EUROPEAN  
SPALLATION  
SOURCE

ESS AD Technical Note  
ESS/AD/0029

**The ESS Cryomodule Design:  
Change towards a Segmented Linac**

13 February 2012

Figure 2: segmented design - warm quads

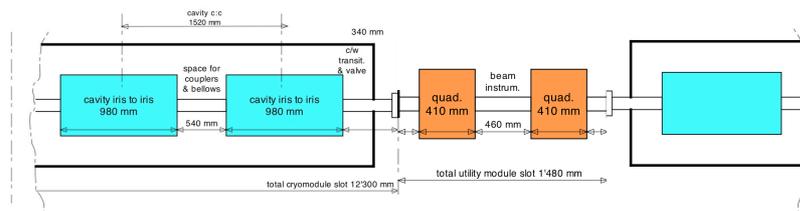
Our latest considerations have shown a number of disadvantages of the hybrid design. The main issues are the significantly more complicated mechanical design and cryogenic flow scheme as well as the increased production cost associated with the increased complexity.

A secondary issue is the type of quadrupoles that can be used in the utility sections between cryomodules: in a hybrid design, the quadrupoles must be superconducting (SC), because there is no warm space for normal conducting (NC) magnets - whereas in a segmented design, the quadrupoles can either be SC magnets located inside the cryomodules or NC magnets located in the warm utility section.

Design 2a: segmented design with warm NC quadrupoles, see Figure 2

Design 2b: segmented design with cold SC quadrupoles, see Figure 3

It is therefore our recommendation to abandon the hybrid cryomodule design and to introduce a segmented cryomodule - with normal conducting quadrupoles in the warm utility sections - for the next iteration of the linac layout.
